**From:** WILLIFORD Dennis (AREVA) [Dennis.Williford@areva.com]  
**Sent:** Thursday, August 25, 2011 3:38 PM  
**To:** Tesfaye, Getachew  
**Cc:** BENNETT Kathy (AREVA); CRIBB Arnie (EXTERNAL AREVA); DELANO Karen (AREVA); HALLINGER Pat (EXTERNAL AREVA); HATHCOCK Phillip (AREVA); ROMINE Judy (AREVA); RYAN Tom (AREVA); WELLS Russell (AREVA); HARRINGTON James (AREVA); WILLIAMSON Rick (AREVA)  
**Subject:** DRAFT Response to U.S. EPR Design Certification Application RAI No. 467, FSAR Ch. 3, Question 03.06.03-28  
**Attachments:** RAI 467 Q.3-6-3-28 Resp. Master US EPR DC Draft.pdf

**Request for Additional Information No. 467(5333, 5344)  
Question 03.06.03-28**

**Question 03.06.03-28:****Follow-up to RAI 265, Question 03.06.03-26**

Figure 3.6.3-12—ALL for Reactor Vessel Outlet Nozzle Region at Hot Leg (Location 1)

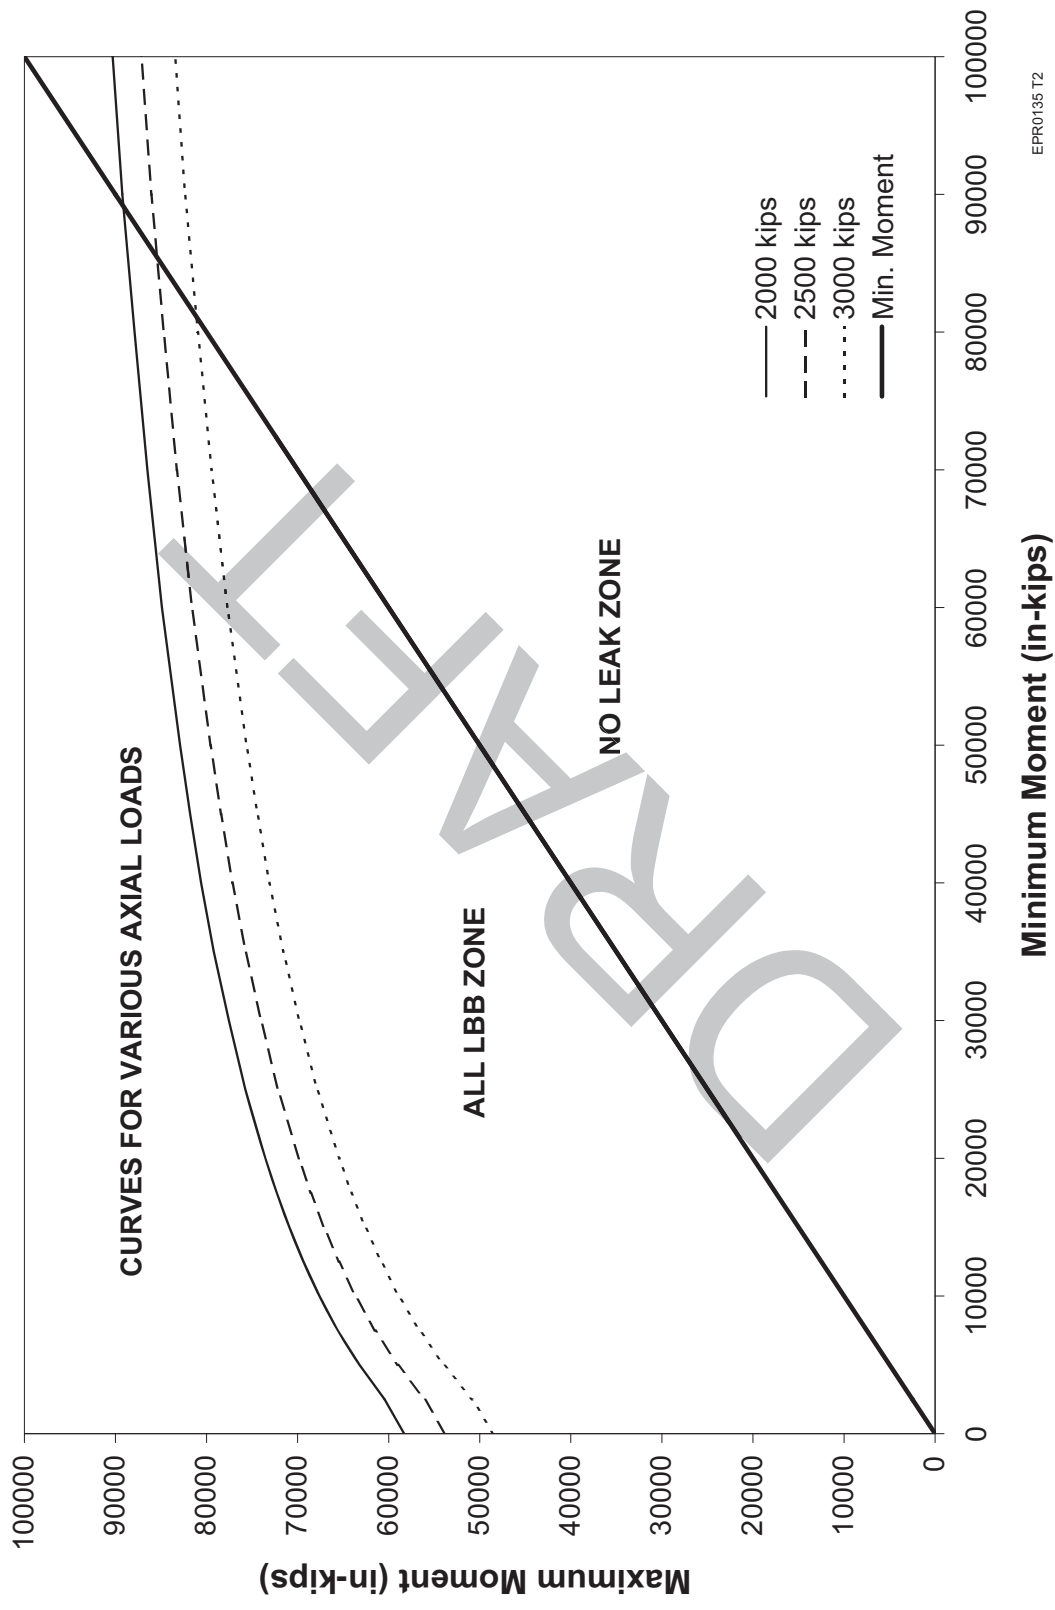
The Allowable Load Limit (ALL) Diagrams are presented in FSAR Tier 2, Section 3.6.3, Figure 3.6.3-12 through Figure 3.6.3-23 for the Main Steam Line (MSL), Main Coolant Line (MCL), and the Surge Line (SL) cases. As a result of the confirmatory calculations performed by the staff and the resulting RAI 265 Question 03.06.03-26, AREVA proposed (i.e., in its Supplemental 5 response to RAI 265 dated September 30, 2010) revising FSAR Tier 2, Figures 3.6.3-18, 3.6.3-19 and 3.6.3-20. Based on a telephone conference call with the applicant on April 7, 2010, the staff understood that AREVA would also revise the remaining ALL diagrams for MCL, MSL, and SL per the same procedure used for the SL. As stated in the telecon dated December 15, 2010, AREVA is requested to provide the NRC staff with revised versions of FSAR Tier 2, Figures 3.6.3-12,-13,-14,-15,-16,-17,-21,-22, and -23.

As noted in the question, the revised ALL diagrams for the SL were provided to the NRC in the Response to RAI 265, Supplement 5, Question 03.06.03-26. U.S. EPR FSAR Tier 2, Section 3.6.3 will be revised to include the revised ALL diagrams for the MCL. Corresponding changes will be made to the text and tables. The ALL diagrams for the MSL do not need to be revised for the following reasons:

vessel outlet nozzle at the Alloy 52 weld fusion line region are depicted in Figure 3.6.3-12—ALL for Reactor Vessel Outlet Nozzle Region at Hot Leg (Location 1). Similarly, the results for other components are shown in the figures as listed below:
